DOUGLAS 4TH STREET UTILITIES AND DRAINAGE Contract No. BE21-215

ADDENDUM NO.: ONE

April 2, 2021

FENCE, BASE LINER
 & AREA DRAIN
 DETAILS

1
11 FENCE AND POST DETAIL
SCALE: NOT TO SCALE

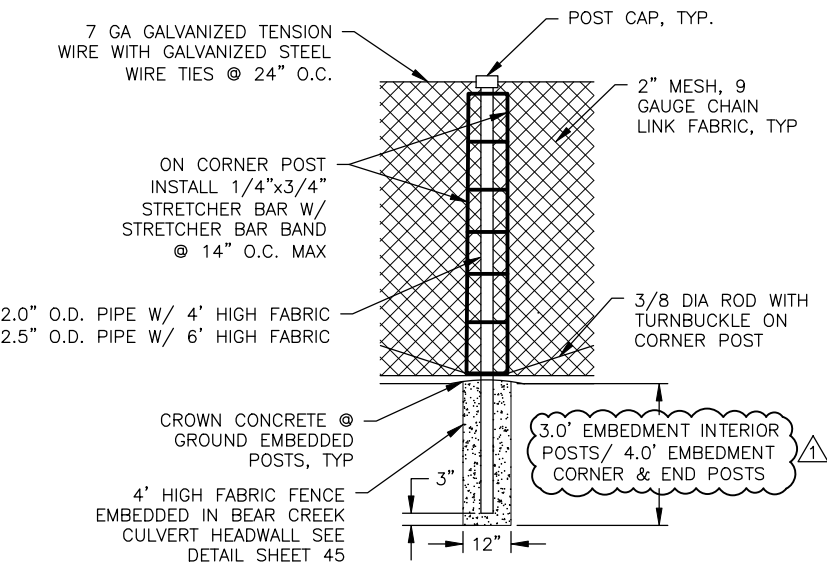
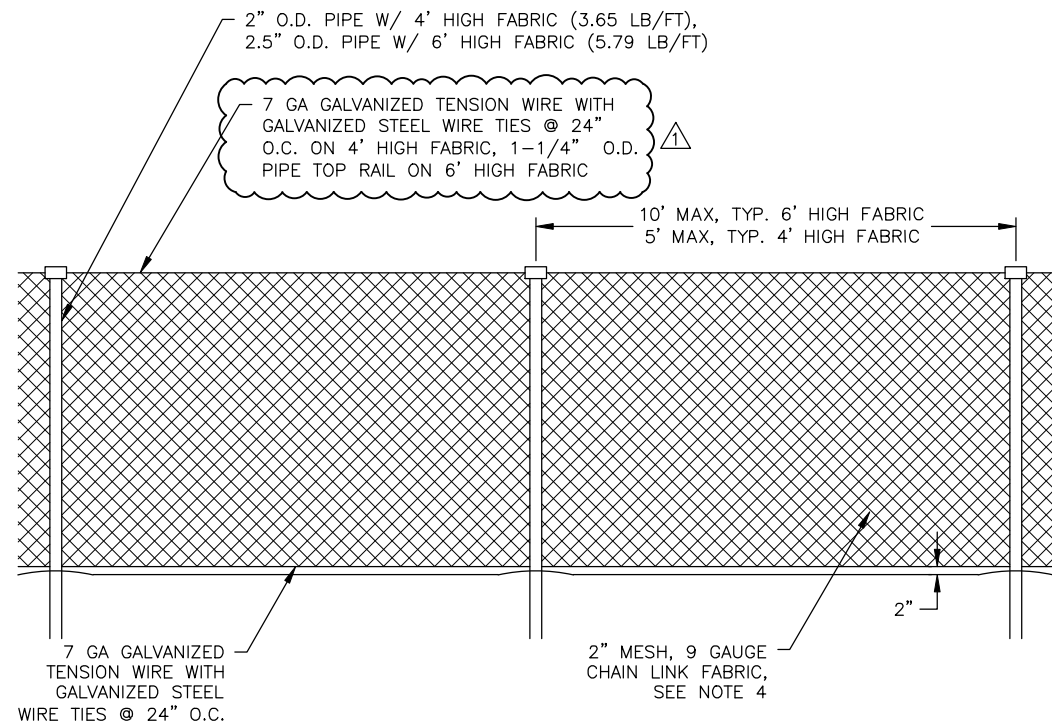
Question: "Are you wanting the posts for the 6' fence as well as the 4' fence to be the same? Or are you wanting the corner posts to be a size bigger?"

Item No. 3 Drawing Sheet 11 of 46, titled “FENCE, BASE LINER & AREA DRAIN DETAILS”, ***Delete*** in its entirety and ***Replace*** with:

Response: Per the Fence and Post Detail on sheet 11 of the plans the 4' posts shall be 2" O.D. pipe and the 6' posts shall be 2.5" O.D. pipe. Corner posts shall be the same size as the interior posts. The project manual has been modified per this addendum to clarify this.

Attached Drawing Sheet 11 of 46, titled “FENCE, BASE LINER & AREA DRAIN DETAILS”, revised per Revision 1 on 04/01/2021

RECORD OF REVISIONS			
No.	DATE	DESCRIPTION	BY
1	04/01/2021	UPDATED NOTE TO REFLECT TOP RAIL ON 6' FABRIC & 4' EMBEDMENT DEPTH ON CORNER & END POSTS	LC
